**North Coast Regional Water Quality Control Board**

SUBJECT: FOX HOLLOW CONSTRUCTION SITE INSPECTION SUMMARY

# Figure 1: Pre-Project Wetland Delineation

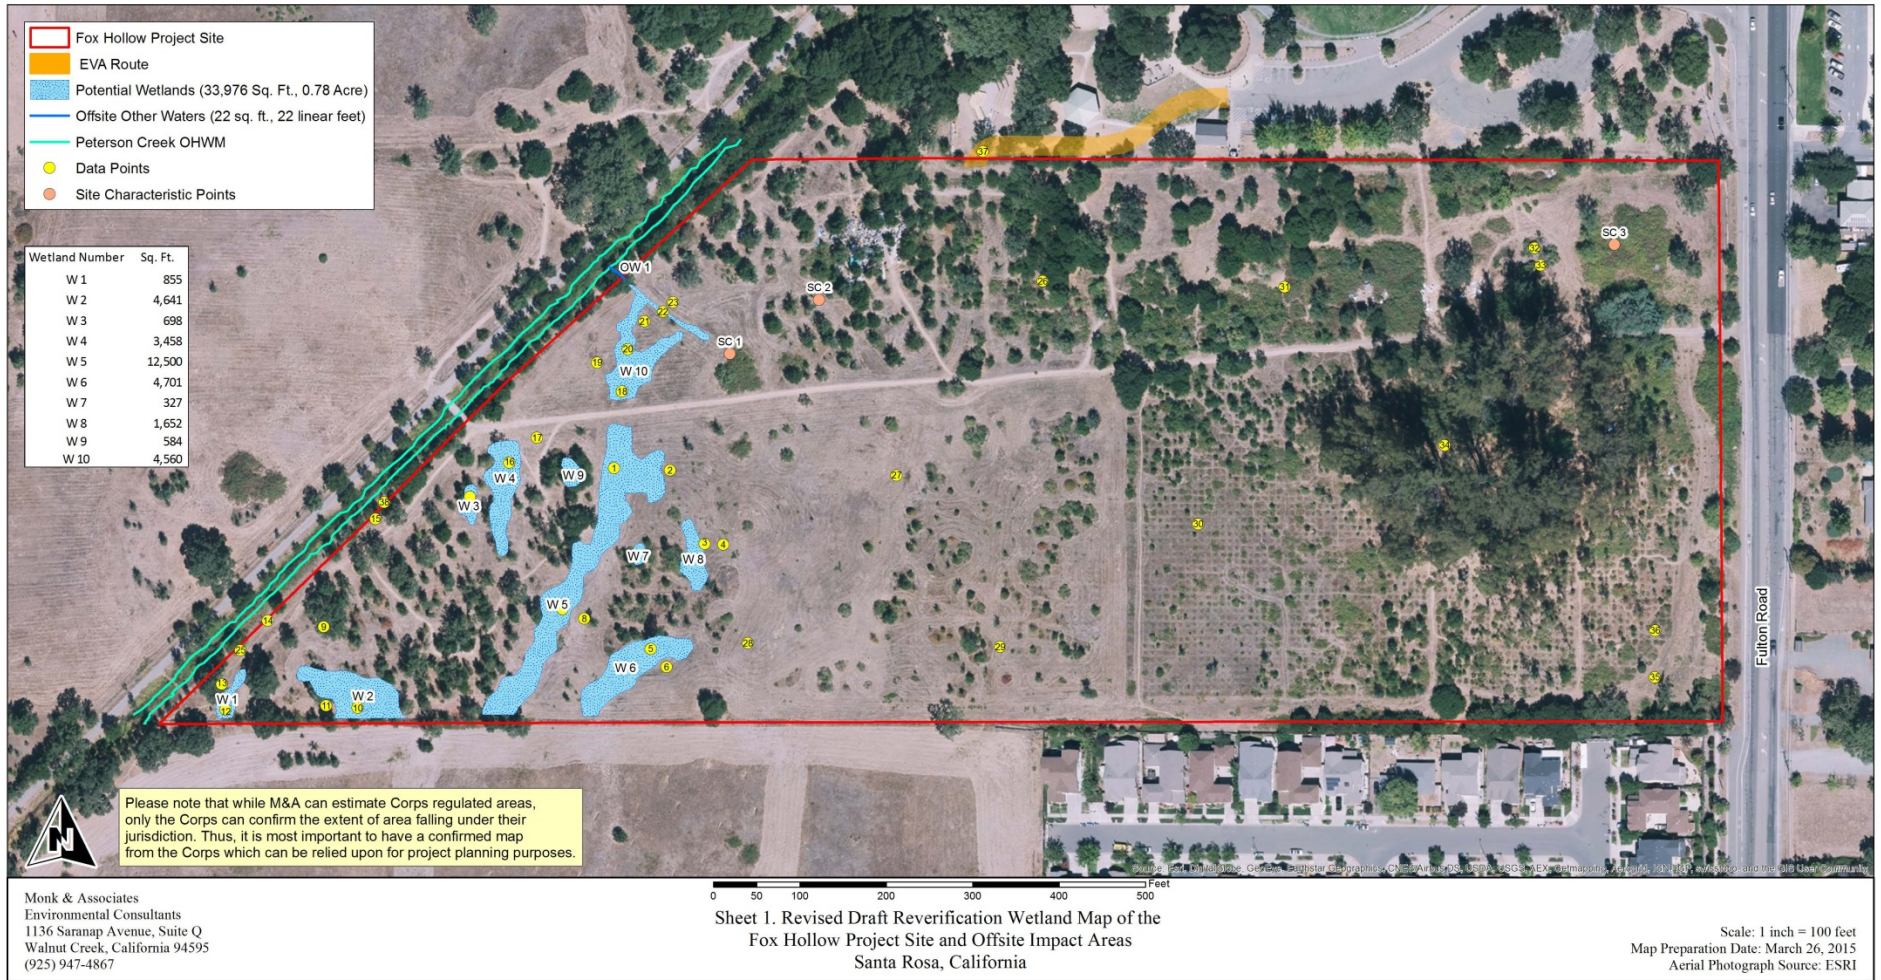
had been impacted by construction runoff. We did not see any indication that the wetland had been damaged by turbid runoff (see Photo 12). However, we did observe turbid runoff from the construction site in a wetland immediately adjacent the southern Project site boundary, at the base of a constructed retaining wall (see Photo 13). This wetland appeared to be a wetland identified as "W2" in the 401 certification application materials (see Figure 1). Impacts to this wetland are not permitted by the 401 certification.
